Access Compliance Report

Public Rights-of-Way

Intersection ID: 50600	Main Street: BENDING_BRANCH_RD	Cross Street: HEARTLEAF_RD	Location:	N
ADA ID: 44C84F0F427C	Ramp Type: Perp	Initial Pass/Fail: Fail	Overall Compliance: No	Severity Score: 25

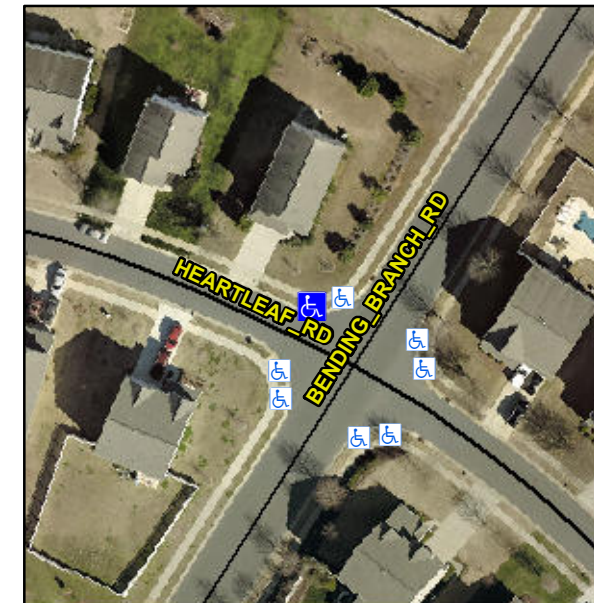
Not Found, R304.2.2, R304.5.3

Compliance	Description	Data	Compliance	Description	Data
N/A	Ramp Length (in)	47.0	No	Ramp Slope (%)	11.4
Yes	Ramp Width (in)	48.0	No	Ramp XSlope (%)	6.3
N/A	Flare Type LT	N/A	N/A	Flare Type RT	N/A
N/A	Flare Slope LT (%)	N/A	N/A	Flare Slope RT (%)	N/A
N/A	Flare Traversable LT?	N/A	N/A	Flare Traversable RT?	N/A
N/A	Landing Length (in)	N/A	N/A	DWS Provided?	N/A
N/A	Landing Width (in)	N/A	N/A	DWS Contrast?	N/A
N/A	Landing Slope (%)	N/A	N/A	DWS Length (in)	N/A
N/A	Landing X Slope (%)	N/A	N/A	DWS Full Width?	N/A
N/A	Landing Curb? (Y/N)	N/A	N/A	DWS Offset (in)	N/A
N/A	Shared Landing?	N/A			
N/A	Gutter Ponding?	N/A	N/A	Gutter Slope (%)	N/A
N/A	Gutter Lip Ht (in)	N/A	N/A	Gutter X Slope (%)	N/A
N/A	Painted X Walk1?	No	N/A	Painted X Walk2?	N/A
	X Walk 1 Direction	To SW		X Walk 2 Direction	N/A
N/A	X Walk 1 Width (in)	N/A	N/A	X Walk 2 Width (in)	N/A
	X Walk 1 Slope (%)	1.8		X Walk 2 Slope (%)	N/A
	X Walk 1 X Slope (%)	5.6		X Walk 2 X Slope (%)	N/A

Remove & Replace Entire Ramp.
